Ground Floor Strategy

Consented Scheme

Revised Scheme

Revised Scheme - Seventh Floor Plan

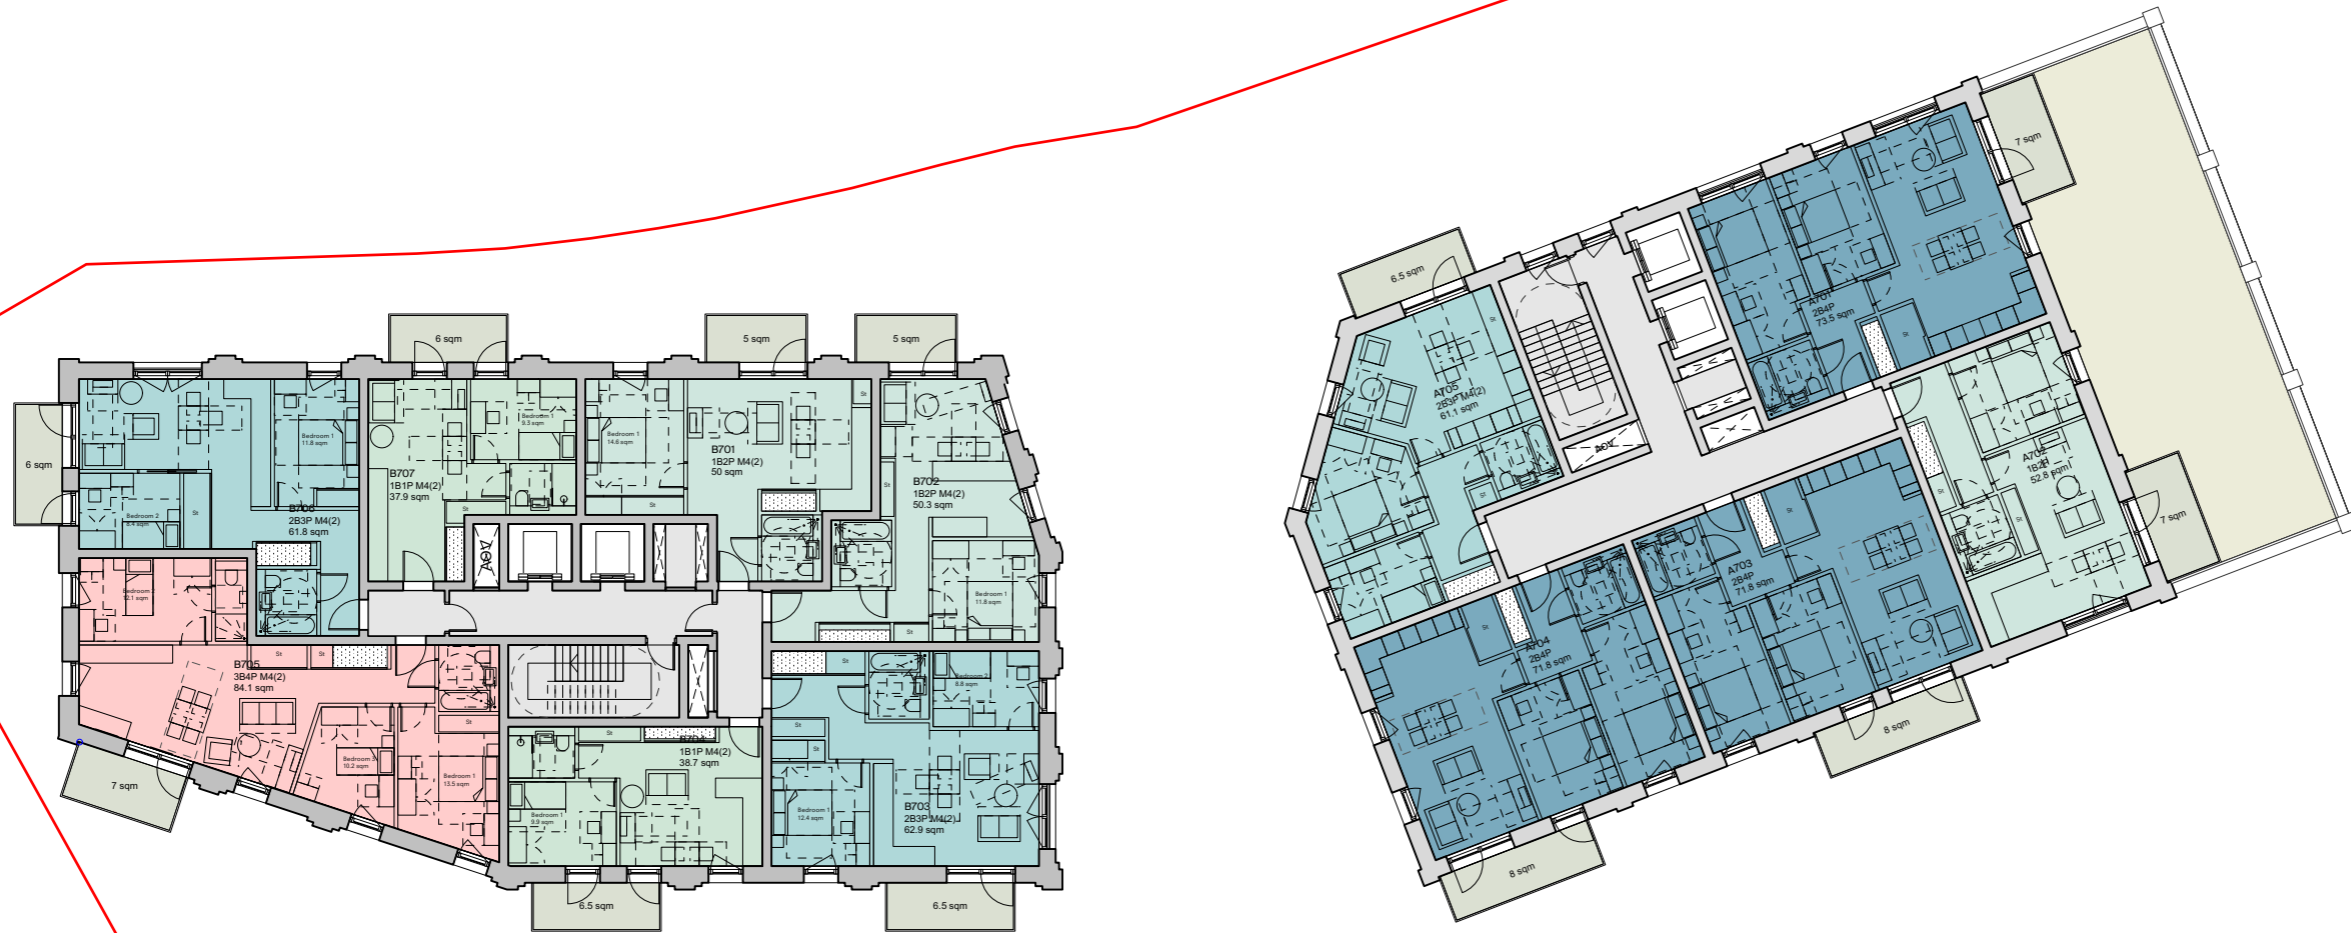
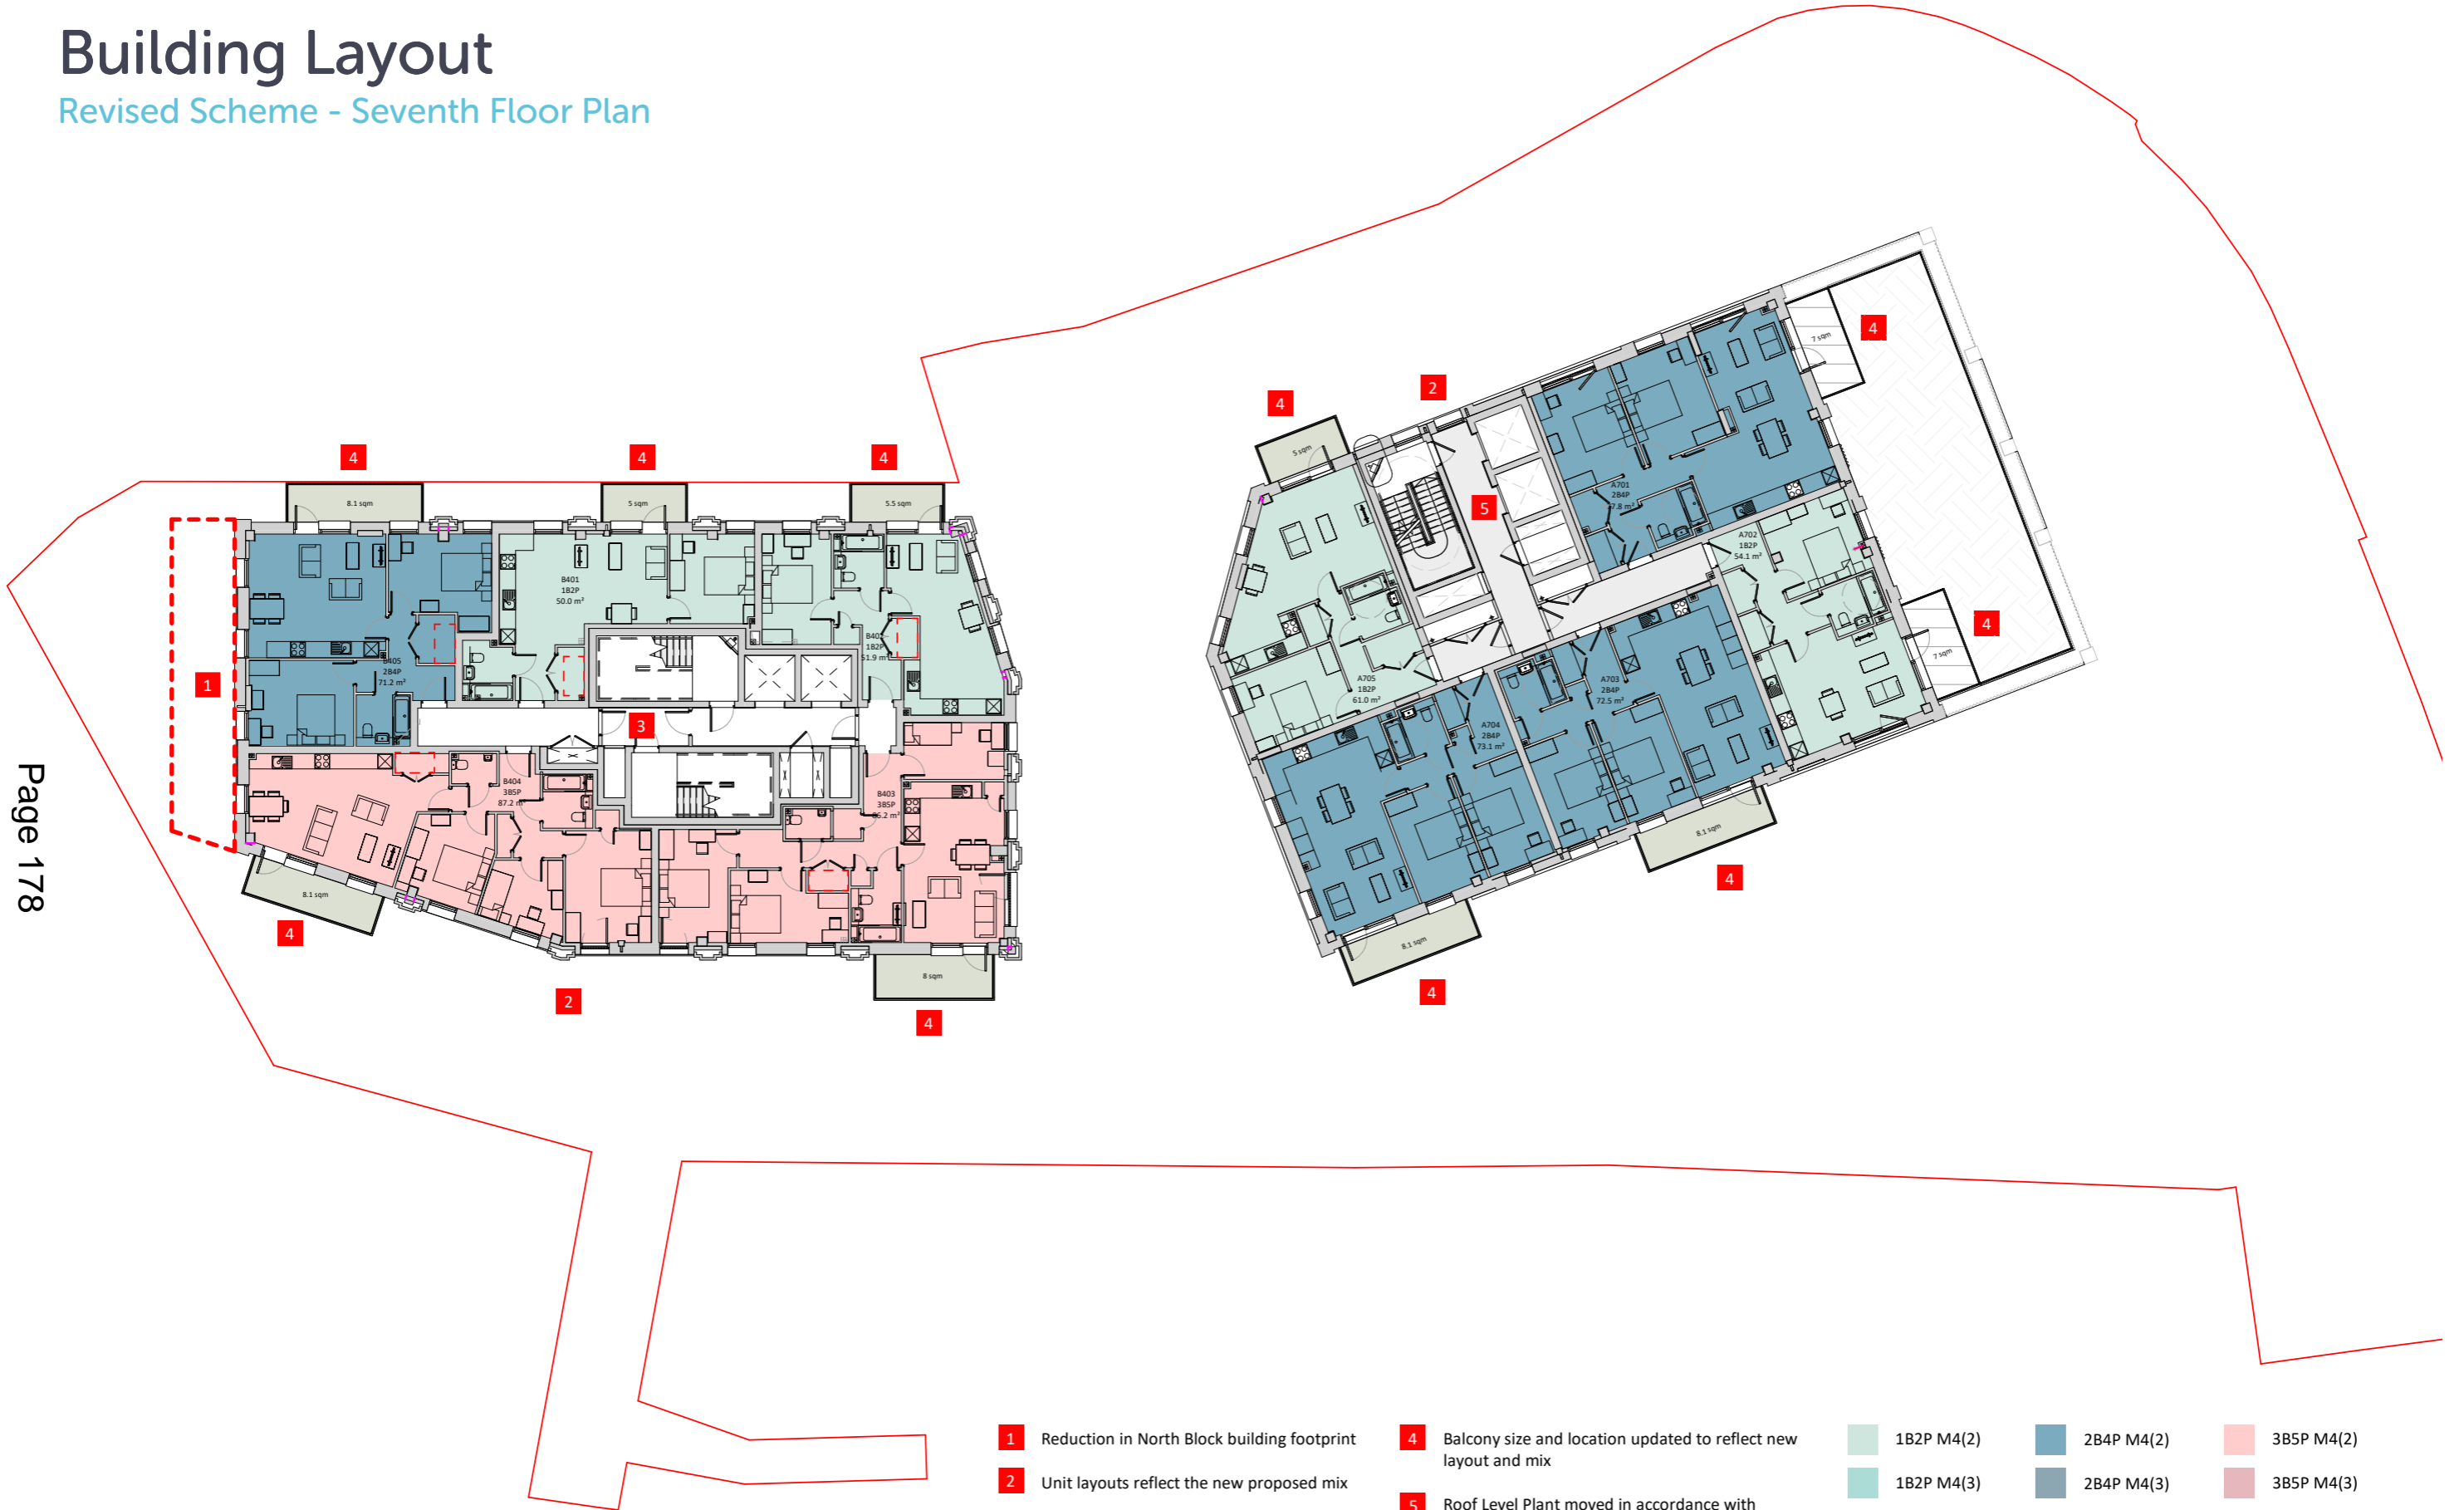
- 1 Reduction in North Block building footprint
 - 2 Unit layouts reflect the new proposed mix
 - 3 Revised core to accommodate secondary escape stair and additional vents and risers

- 4 Balcony size and location updated to reflect new layout and mix
 - 5 Roof Level Plant moved in accordance with below core shift
- | | | |
